UNITED STATES
DEPARTMENT OF THE INTERIOR
BUREAU OF LAND MANAGEMENT

SUNDRY NOTICES AND REPORTS ON WELLS
Do not use this form for proposals to drill or to re-enter an abandoned well. Use Form 3160-3 (APD) for such proposals.

OPERATOR NAME:	COG Operating, LLC
LEASE NO.:	NMNM14903
WELL NAME & NO.:	Corbin Federal #1
US WELL NUMBER:	30-025-25453
LOCATION:	Sec 20/T18S/R33E
COUNTY:	Lea, NM

Type of Action: Plug and Abandonment

PROPOSED
Wellbore Diagram

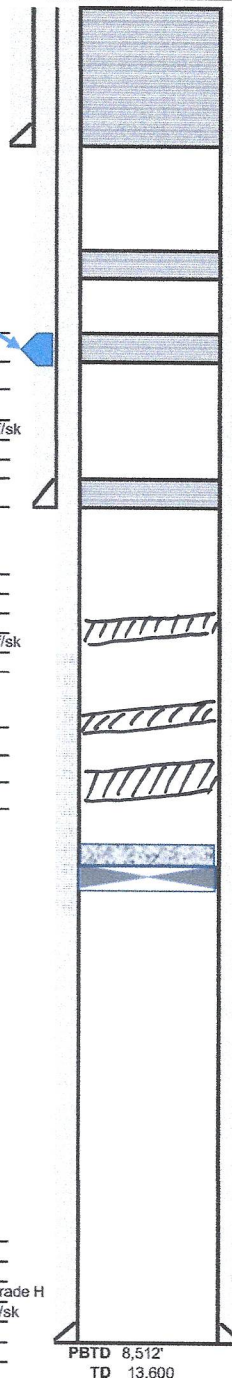
4. Spot ⁴⁸25 sx cmt @ ^{1192'}1700-1500'. WOC & Tag (T/Salt)

2. Spot ⁴⁹25 sx cmt @ ^{4644'}5166-4966'. WOC & Tag (8 5/8" Shoe)

spot cement from 4202' to 4060'. 25 SXS

spot cement from 5756' to 5598'. 25 SXS

spot cement from 7185' to 7011'. 25 SXS

1. Tag existing 5 1/2" CIBP @ 8547' w/ 35' cmt cap on top.
CIBP set at 8,547' on 5/9/2023
w/ 35' cmt on top (PBTD = 8,512') leak test.

* Run CBL from CIBP to surface.

Plug Abandonment NOI Proposed

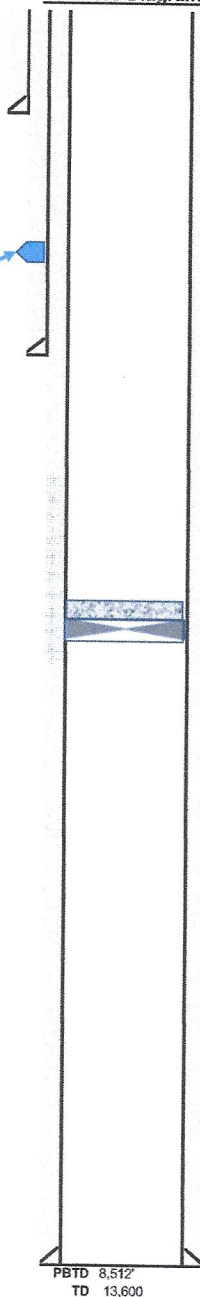
1. Tag existing 5 1/2" CIBP @ 8547' w/ 35' cmt cap on top. *Leak test casing.*

2. Spot ⁴⁸25 sx cmt @ 5166-⁴⁶⁴⁹4966'. WOC & Tag (8 5/8" Shoe)

4. Spot ⁴⁸25 sx cmt @ 1700-¹¹¹²1500'. WOC & Tag (T/Salt)

→ Spot cement from 7183' to 7011'. (Bone Springs @ 7133') 25 sacks class C.

Spot cement from 5756' to 5598'. (Delaware @ 5706') 25 sacks class C.

→ Spot cement from 4202' to 4060'. (Queen @ 4152') 25 sacks class C.

* Run CBL from CIBP to surface.
